From: City of La Crosse Notices - No Reply
Sent: Monday, August 3, 2026 2:02 PM
To: Craig, Sondra; Elsen, Nikki; Janssen, Barb; Kahlow, Chris; Sleznikow, Larry; Trost, Jennifer; Mindel, Mackenzie; Dickinson, Tamra; Goggin, Erin; Steele, Annette; Washington-Spivey, Shaundel; Weston, Lisa; Newberry, Aron; Bedford, Crystal; Padesky, Gary; Stine, Olivia; Northwood, Rosanne
Subject: City Council Contact Form: Suggested larger revisions to Bike-Ped master plan
Attachments: Downtown bike plan refurbish.png

Subject: Suggested larger revisions to Bike-Ped master plan

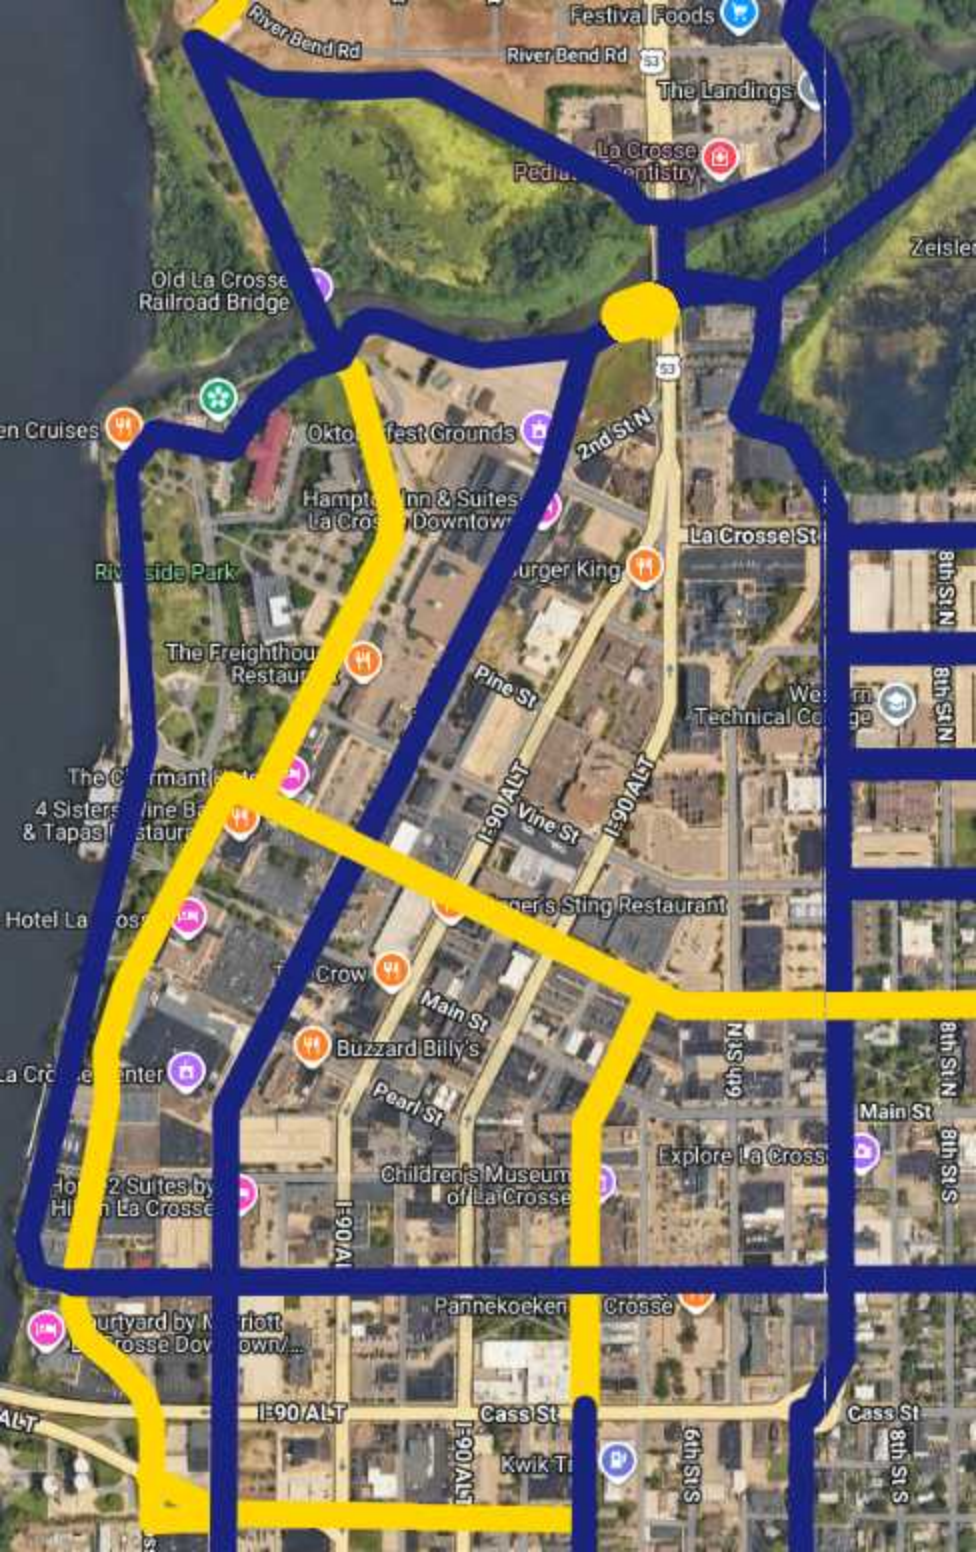
In the attached map, blue = existing and yellow = add; streets I suggest removing are absent.

Add:
Cameron from bridge to 5th
We should be directing cyclists to the wider and safer path on the Cameron bridge

5th from Cass to Main (or State)
6th lacks a stop light at Cass and is farther from downtown than 5th, and we already have 5th south from Cass in the plan.
Main and State both have stop lights at 7th, allowing safer left turns for northbound traffic.
State route is a little shorter and clearer and farther north

Connection from trail at South-West Corner of bridge to Copeland
Necessary connection for crossing underneath Copeland bridge to avoid car traffic and roundabout.

Front St from northern terminus to Cameron
Fast, low-traffic corridor with existing connection to Asfoor trail
Don't add from Cameron to Market as this is an active industrial zone and doesn't save much distance; direct traffic to 2nd to get around.

Connection from North-West corner of Asfoor Trail to River Bend Rd
Necessary connection testified to by two desire paths

10th south from Jackson
Obvious neighborhood connection; unclear why it wasn't in before

If Redfield is chosen: bike infrastructure on west side of Losey from Redfield to Green Bay
To encourage people to cross at Green Bay rather than trying to go straight across Losey at Redfield.

9th from South Ave to Farnam and crossing over South
Assuming we go with Redfield, this cobbles together a western terminus for Redfield that connects to something. Currently there is nothing in the plan directing bike traffic once it reaches the end of Redfield at 9th, and cyclists might be tempted to go through a Gundersen parking lot directly ahead.

Barnabee Rd (instead of Sunset Dr)
Sunset is a hill. Barnabee is flat.

Remove:
La Crosse St between 2nd and 7th
This will be a roundabout, which are unaccommodating to bicyclists and pedestrians.

Remove Cass
We should be directing cyclists to the wider and safer path on the Cameron bridge

Remove 6th
6th lacks a stop light at Cass and is farther from downtown than 5th, plus we already have 5th south from Cass

Cancel 3rd/4th bike lanes
These are useless at best, and likely confusing, without the downtown bike lanes

Pine St west of 7th
Extremely low-quality/nonexistent West of 7th and there are no stop lights on 2nd/3rd/4th/7th

Vine St west of 7th
There are no stoplights on 2nd/3rd/4th/7th/West

Sunset Dr
This is a hill.

Front St from Cameron to Market
This is an active industrial zone and sending traffic to 2nd doesn't cost much distance

Consider:
Switching from Main to State
State is the farthest north east-west route through downtown that has stop lights at 2nd/3rd/4th/7th/West and it connects smoothly to 5th, and goes past UWL cleanly.
Main also functions but I see no advantage over State.
State becomes much more obvious if Vine/Pine east-west are removed from west of 7th, as they should be because they do not have stop lights at 2nd/3rd/4th/7th, which makes those streets dangerous and annoying to cross.

Switching from Farnam/Redfield to Adams/Denton
Suggested by someone at a listening session. Denton has a cleaner connection to 7th on the west side than Redfield and a shorter walk from Losey & Denton to an existing stop light on Losey than Redfield has, hopefully discouraging people from trying to cross Losey in the middle of the block. Assuming we eventually build Green Bay St, having a greenway just one block away is absurd.
Adams connects all the way from 3rd/South to State Rd. Functionally very similar to Farnam.
